Revised Structure Type Study

Ramp C over Norfolk Southern Tracks

SCI-823-1603

- ODOT Review Comments of Original Structure Type Study with Consultant Responses

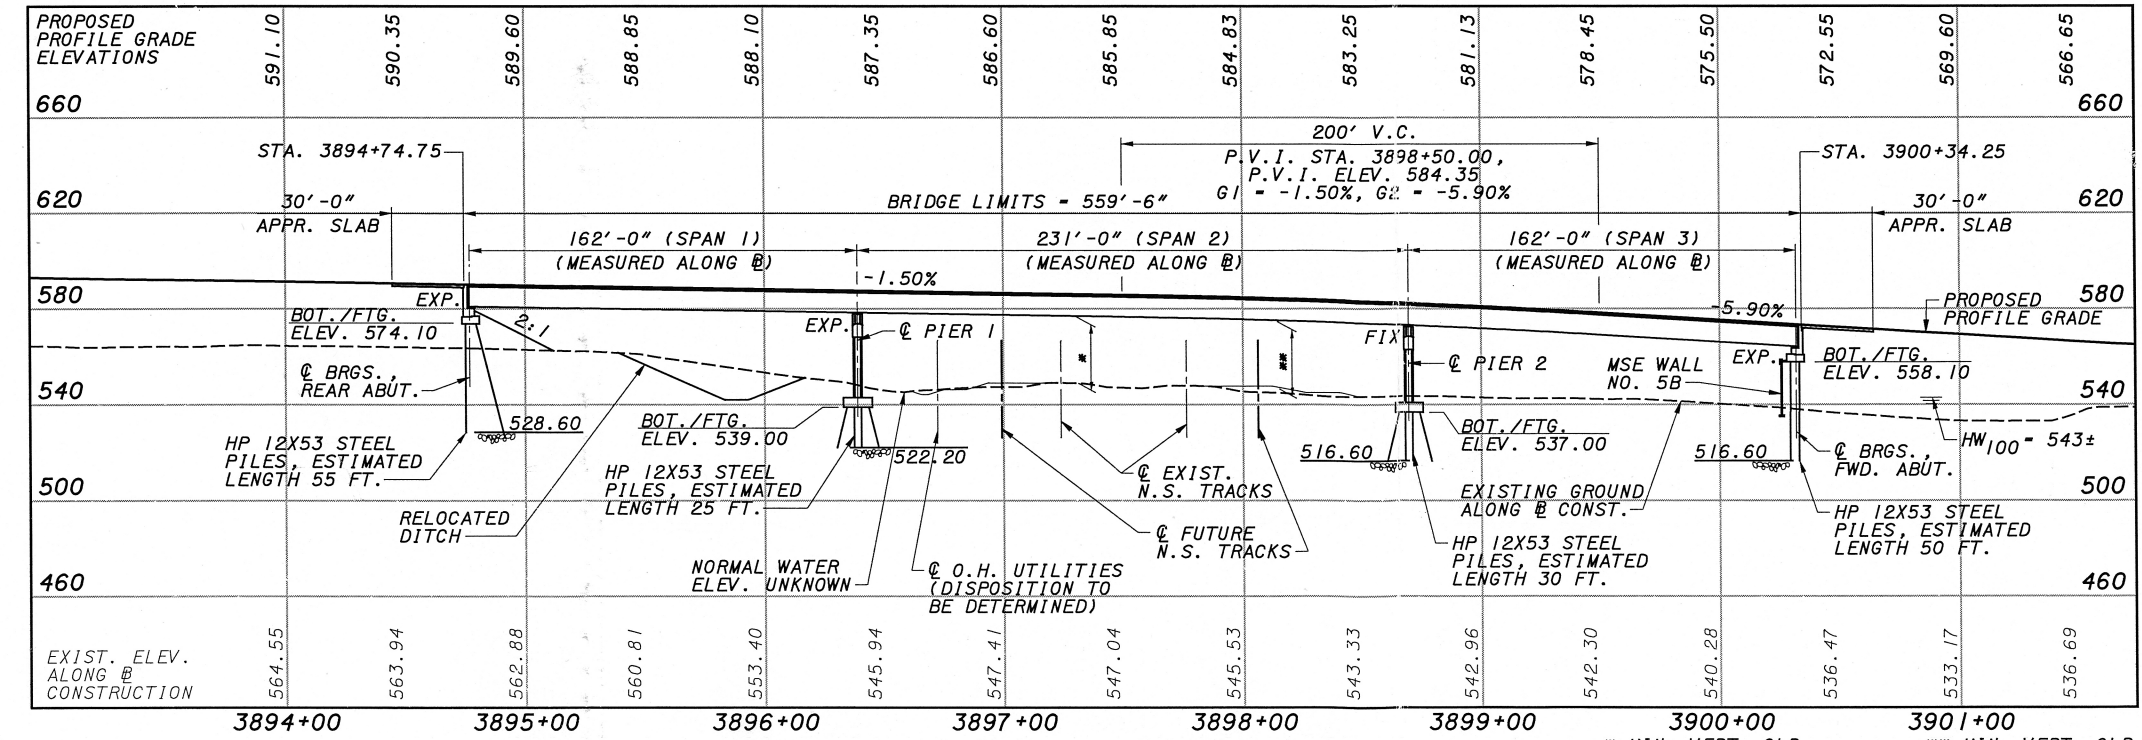
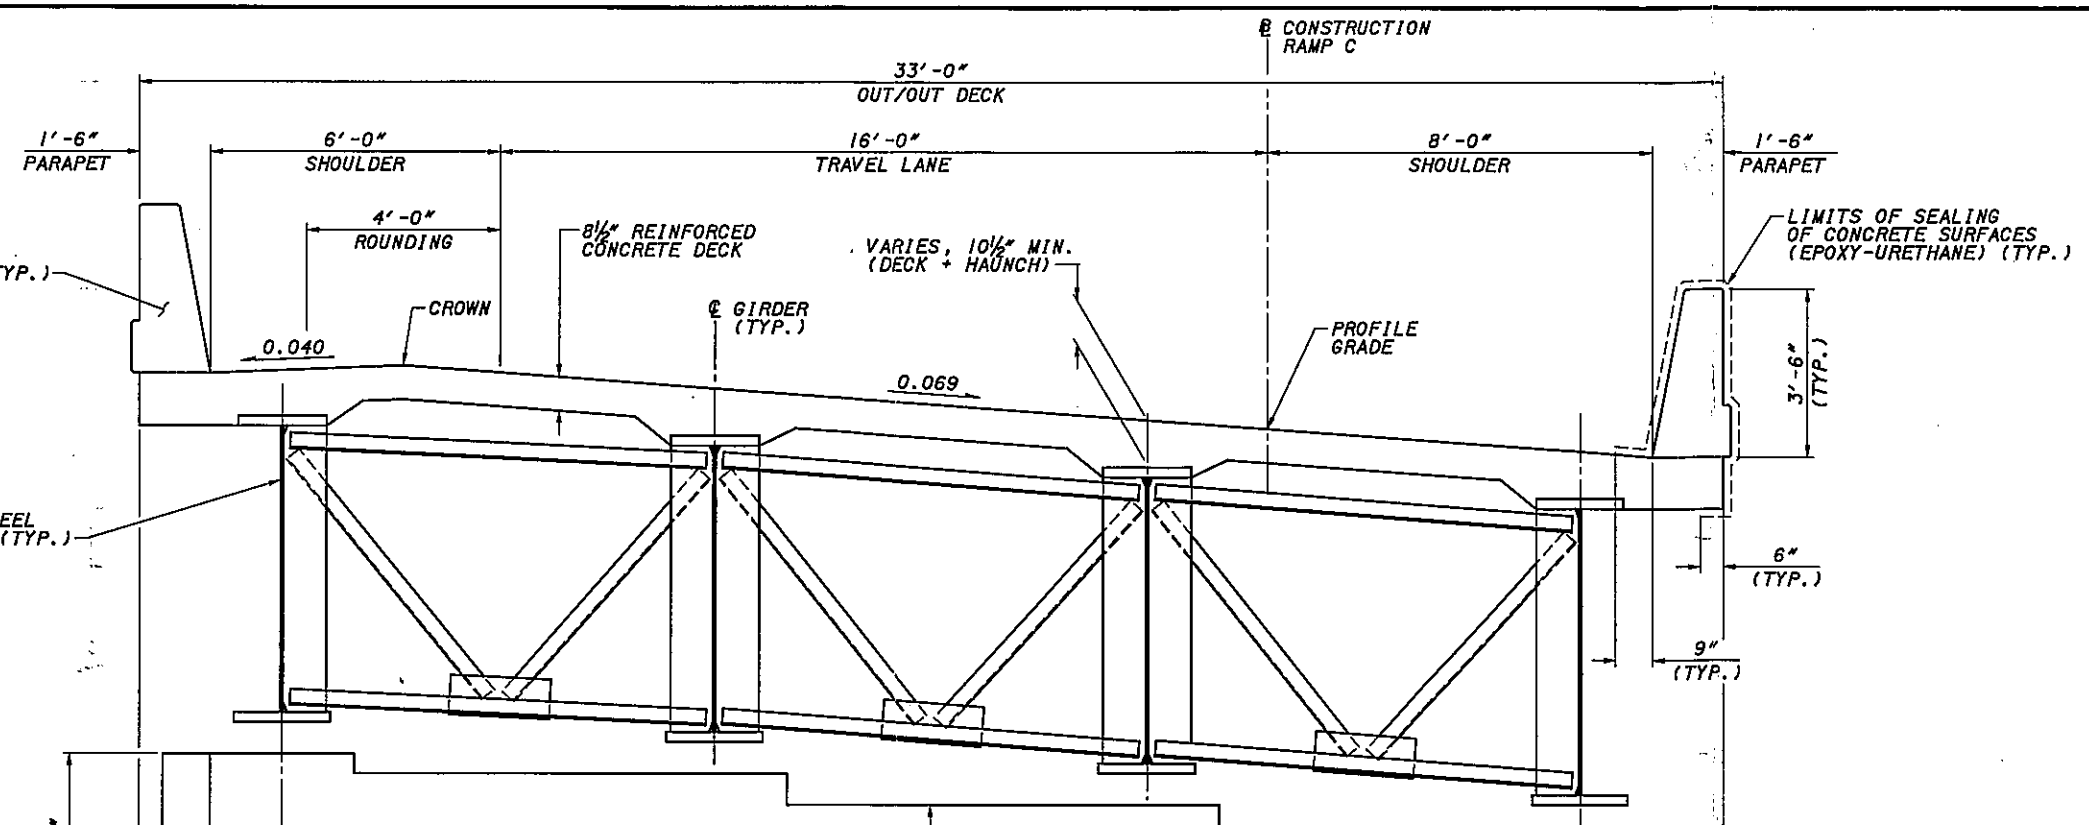
<p>Site Plan (1/3)</p>	<p>7. In the Profile view, a stream is being shown to the north of the proposed pier in Alternate 1. Please show the edge limit of the stream in the Plan view and the direction of the flow. How much flow is in the stream? Please provide additional information.</p>	<p>CH2M HILL will attempt to maintain the existing drainage, grading, and location of the ditch, not stream, in this area for this project. However, the existing crushed aggregate open channel ditch is located in close proximity to the potential future track. Furthermore, realigning the ditch to accommodate substructure units closer to the RR at the clear zone distance will permit shorter span lengths. At the May 2, 2007 meeting with Norfolk Southern representatives at ODOT Central Office, Norfolk Southern concluded that redirecting this open channel to allow shorter span lengths would be permitted. As a result, CH2M HILL will investigate various alternatives with substructure units located both inside and outside of the existing ditch.</p> <p>Existing and proposed flow arrows for this ditch will be provided in the plans.</p>

<p>Site Plan (1/3)</p>	<p>8. Show the vertical clearances for both railroad tracks. Profile view only showed the vertical clearance for one of the railroad tracks.</p>	<p>Will comply.</p>
<p>Site Plan (1/3)</p>	<p>9. Verify all vertical clearances. Norfolk Southern Railroad requires that the 23'-0" minimum vertical clearance is measured from top of high rail to the lowest point of the structure <u>in the horizontal clearance area.</u></p>	<p>Will comply.</p>
